11767 HORROBIN FARM, TURTON

ICF APPROVAL DRAWING PACK

Issue P02 | 15.09.26

QUESTIONS FOR THE ENGINEER

DRAWING TITLE
GROUND FLOOR ICF GENERAL ARRANGEMENT

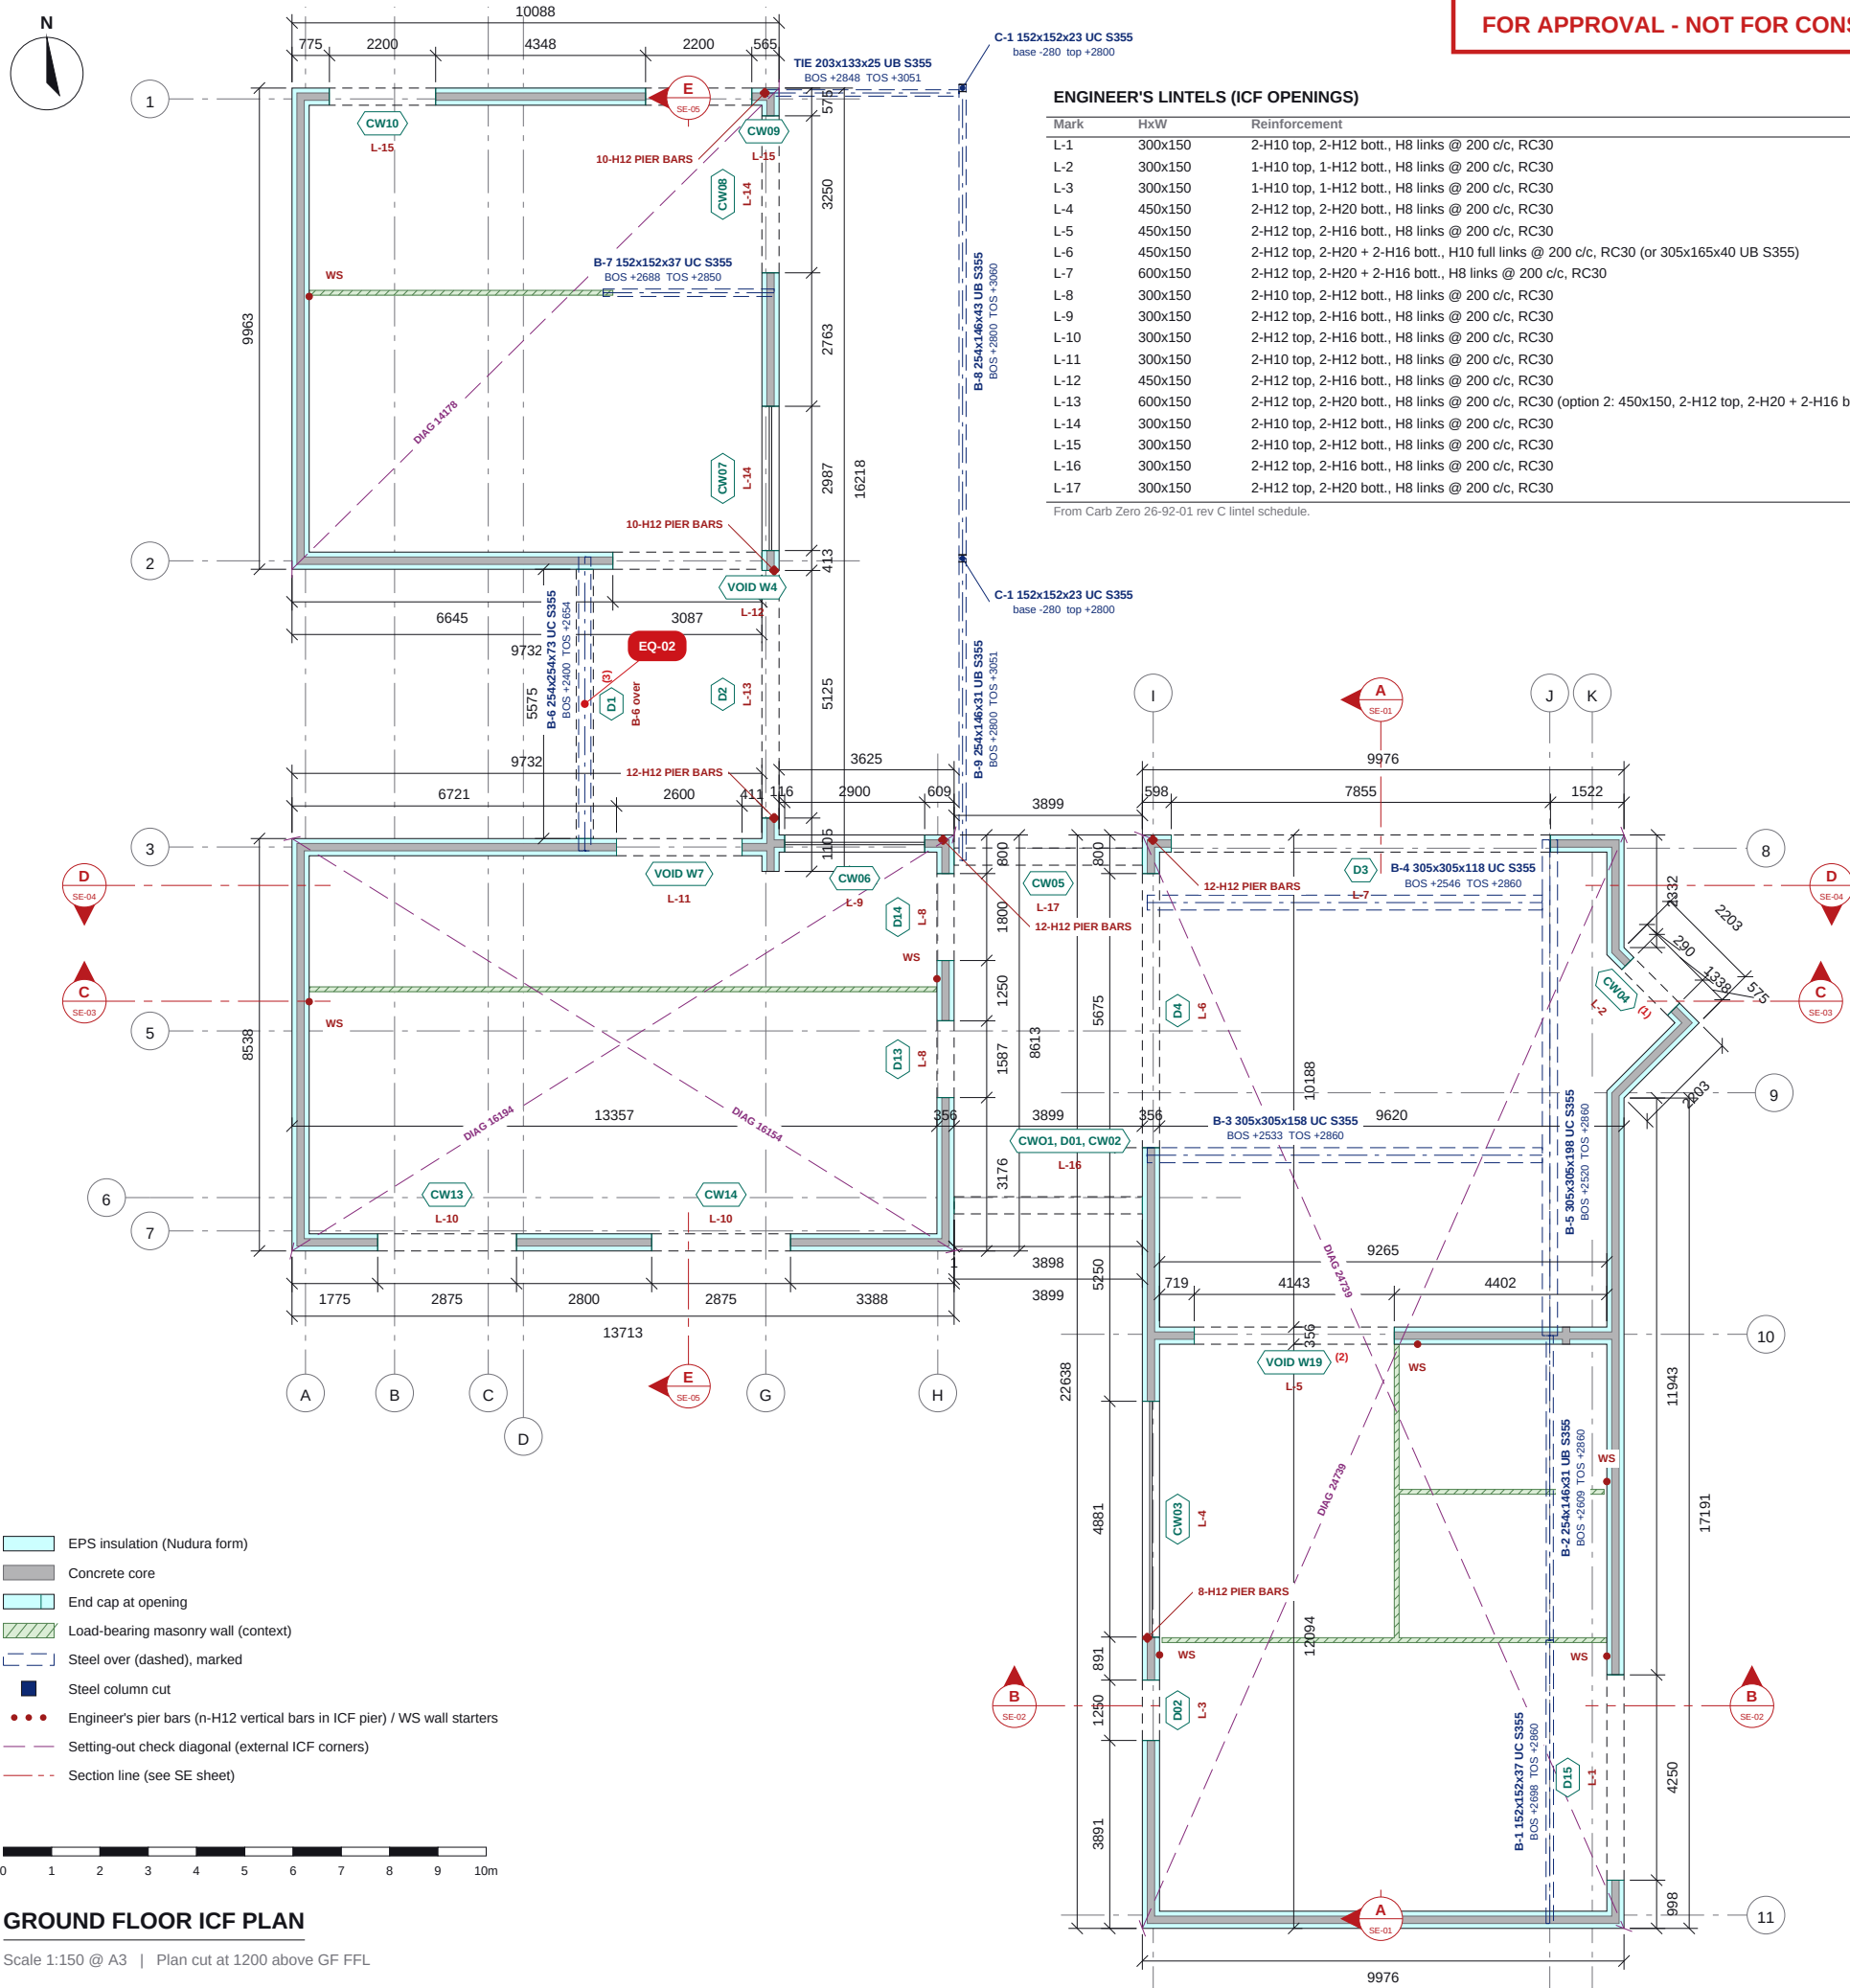
REV	DATE	DESCRIPTION
P01	14.09.26	Approval issue
P02	15.09.26	CW13 lintel L-18 revised to L-10 (engineer, EQ-01 closed)

Status: Open | see GA-01

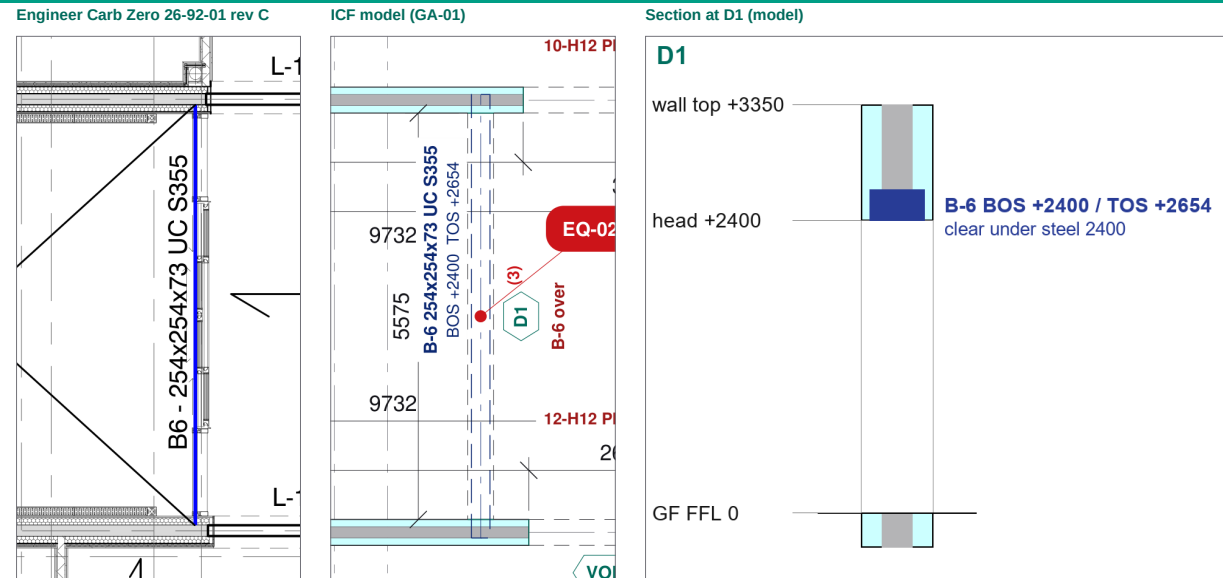
ISSUE	D1 is the 5575 wide full-length opening in the ICF wall between the conservatory and the room to its east (Wall 21). Your drawing gives it no lintel mark and shows B-6 254x254x73 UC S355 (with 200x100x10 ledger angle one side) along that line. We have modelled B-6 at BOS +2400 / TOS +2654 as the head of the opening, with the structural opening in the ICF up to +2654 and ICF over the steel to the wall top at +3350, giving 2400 clear under the steel.
-------	---

QUESTION Please confirm that B-6 forms the head of D1 as described (clear opening 2400 under B-6, ICF bearing on the steel above), or advise the intended arrangement.
